January 6, 2000
1940-99-20662

Subject: Oyster Creek Nuclear Generating Station
Facility License No. DPR-16
Docket No. 50-219
Response to Request for Additional Information re:
Proposed License Amendment for Spent Fuel Pool Expansion

Enclosure 1

**OCNGS SSE Time Histories at El. 75'-3"
PSD Functions Vs Targets**

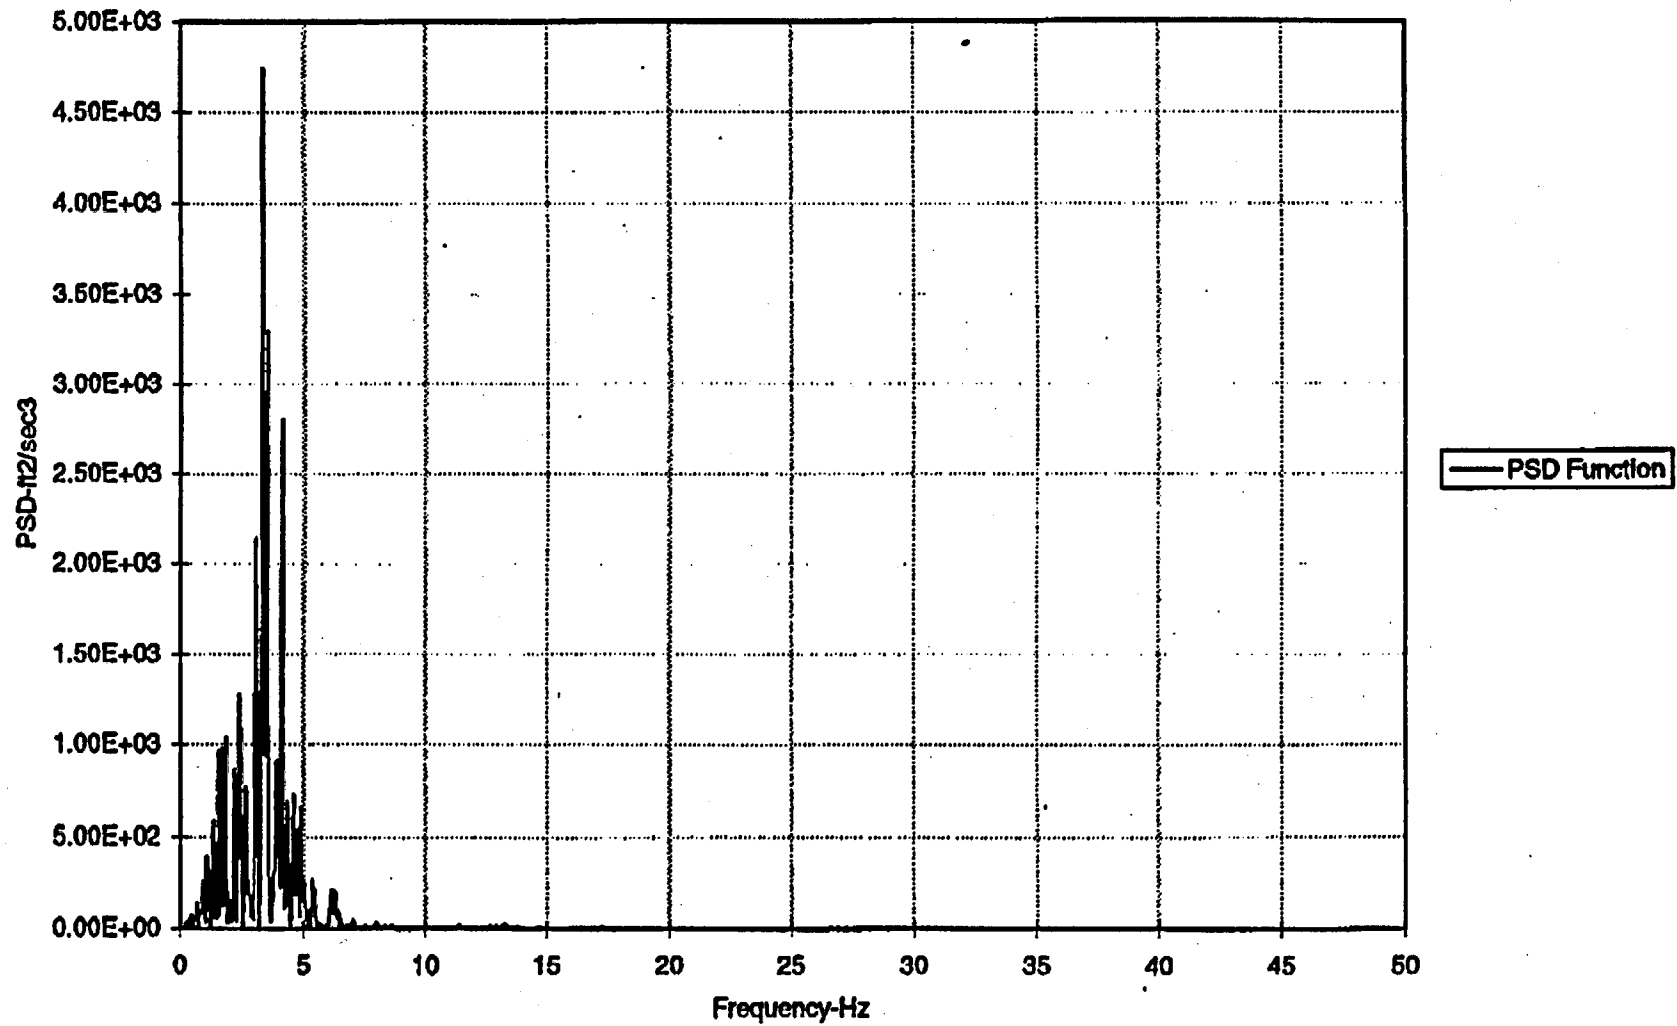
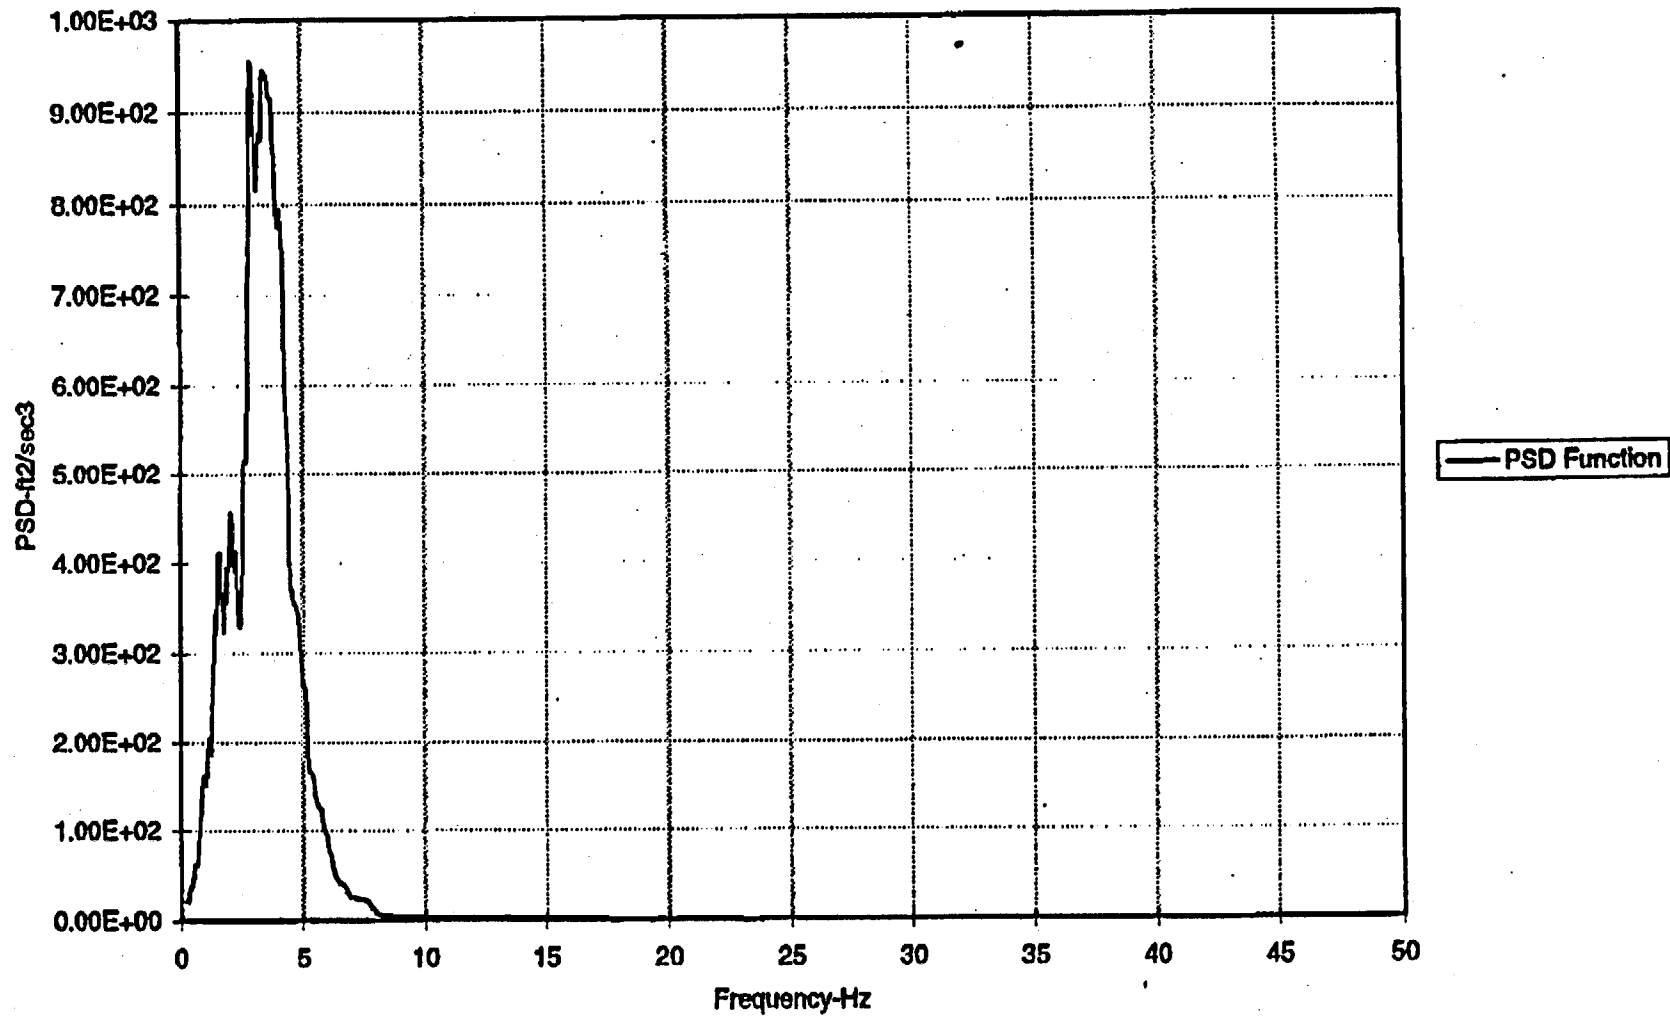
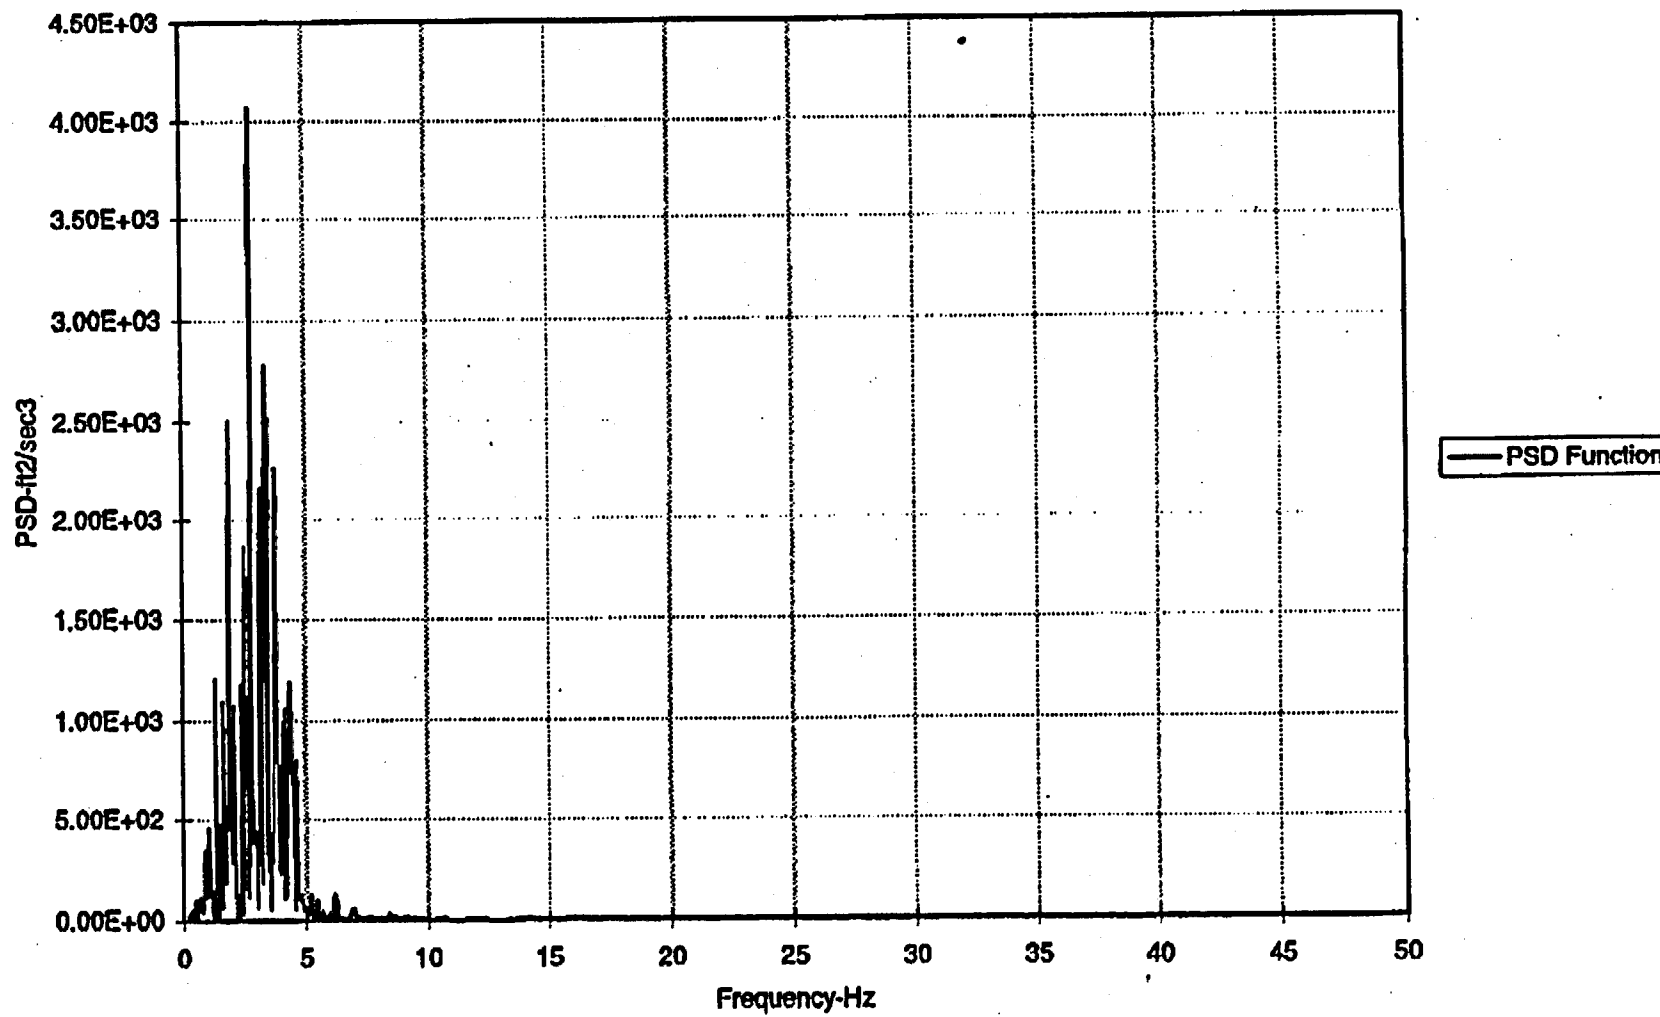
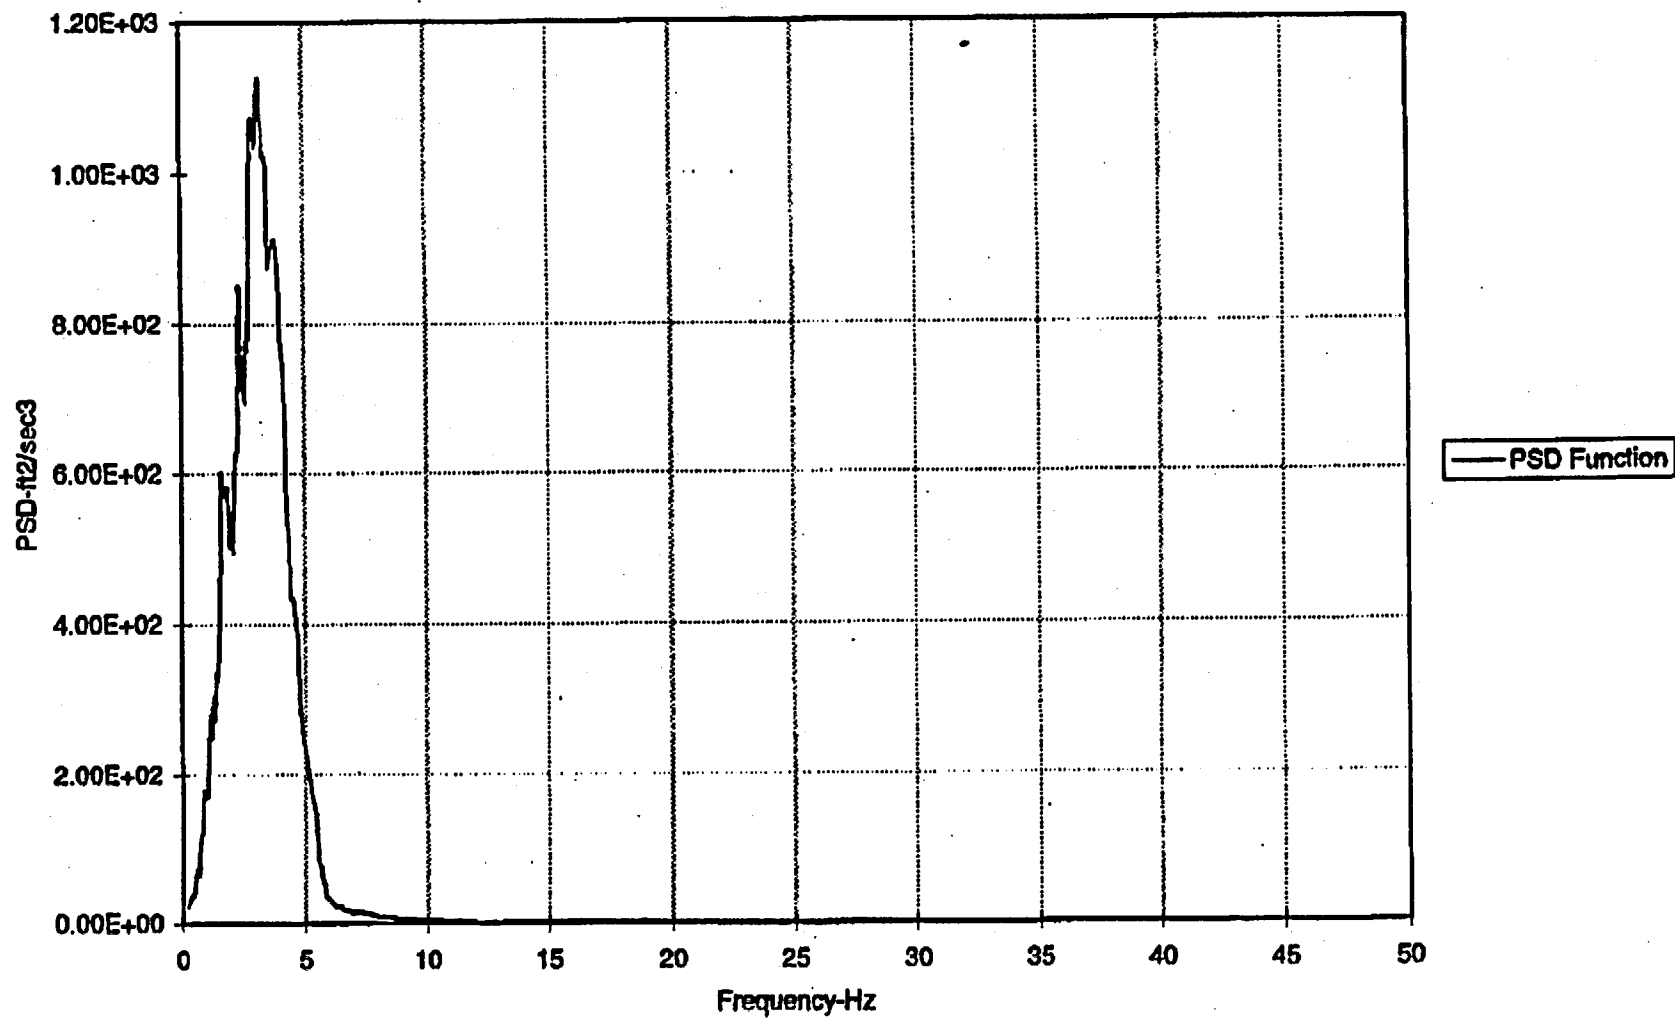
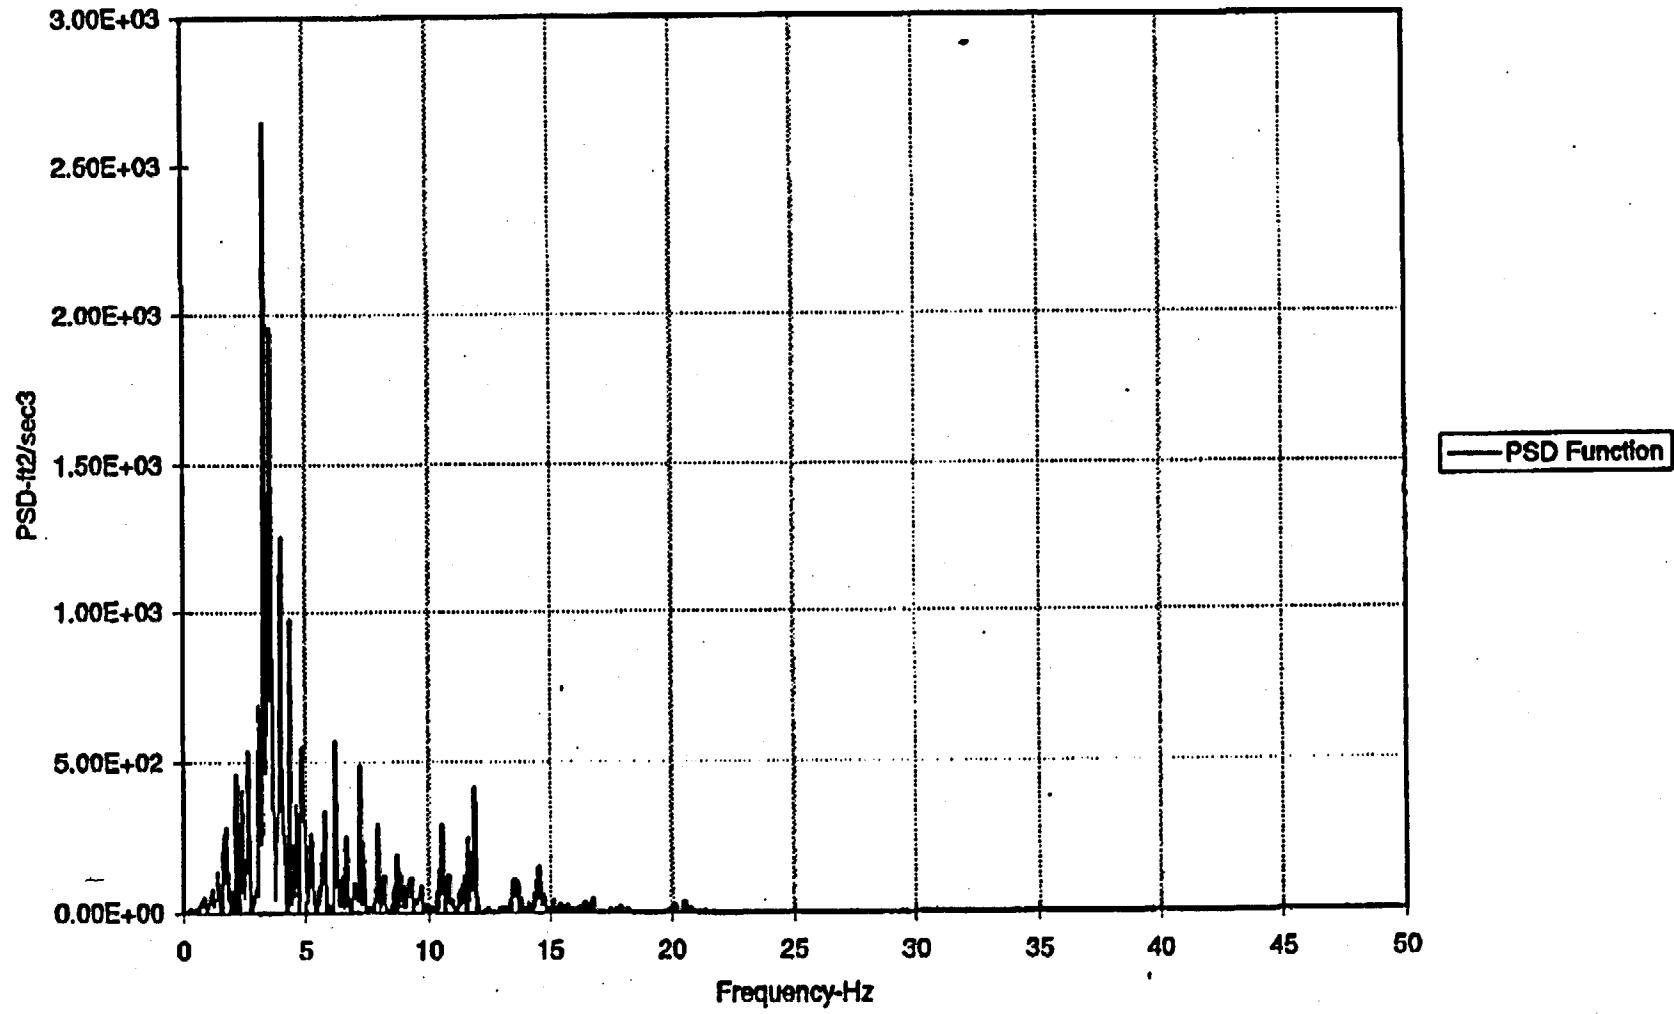
- (c) Provide the physical dimensions of the racks, and the gaps between the racks and the gaps between the racks and the spent fuel pool (SFP) walls.
- (d) Demonstrate that the artificial seismic ground motion time histories used in the analyses satisfy the power spectral density (PSD) requirement of SRP 3.7.1.

The SSE time histories for use in the DYNARACK analyses were also developed by EQE. Attachment 1.4 presents Section 7.0 and Figures 7-1 through 7-6 from the EQE calculation which demonstrate that the time histories derived contain the correct energy distribution with respect to frequency. The OBE time histories, which were generated by Holtec International, also meet the PSD requirements of SRP 3.7.1. Attachment 1.5 contains figures, which provide a comparison of the PSD curves associated with the generated time histories and the PSD curves associated with the design basis response spectra. These figures clearly show that the generated PSD curves envelop the target curves over the entire frequency range.

The "raw" and smooth power spectral density functions are shown in Figures 7-1 to 7-6. There, it is shown that the generated horizontal time histories have the energy concentrated in the 3 to 4 Hz range and practically no energy after 8 to 10 Hz. The vertical time history has a large amount of energy in the 3 to 4 Hz range but also has energy between 4 and 20 Hz. This is consistent with the target floor response spectra and with the characteristics of the dynamic response of the reactor building.
